AMENDMENTS TO THE DRAWINGS:

REMARKS

FIG. 3J

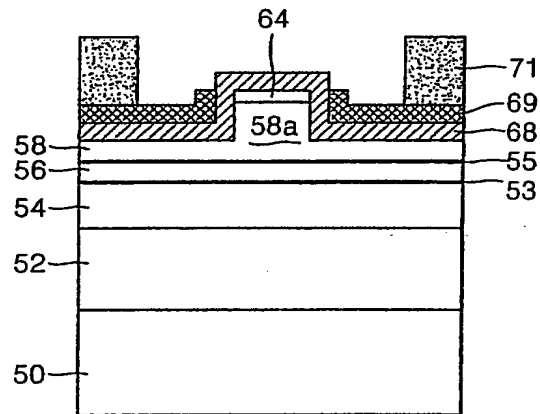
The attached drawing sheets include changes to Figs. 1 and 3J. These sheets replace the original sheets that includes Figs. 1 and 2 and Figs. 3I and 3J, respectively. In Replacement Sheet 1, Fig. 1 was amended to include a "Prior Art" legend. In Replacement Sheet 2, Fig. 3J was amended to change reference number "69a" to "69b".

Fig. 1 was objected to for failing to include a prior art legend. Fig. 1 has been amended to address the Examiner's concerns. In addition, Fig. 3J has been amended to change reference number "69a" to "69b". Applicants respectfully request that the objection to the drawings be withdrawn.
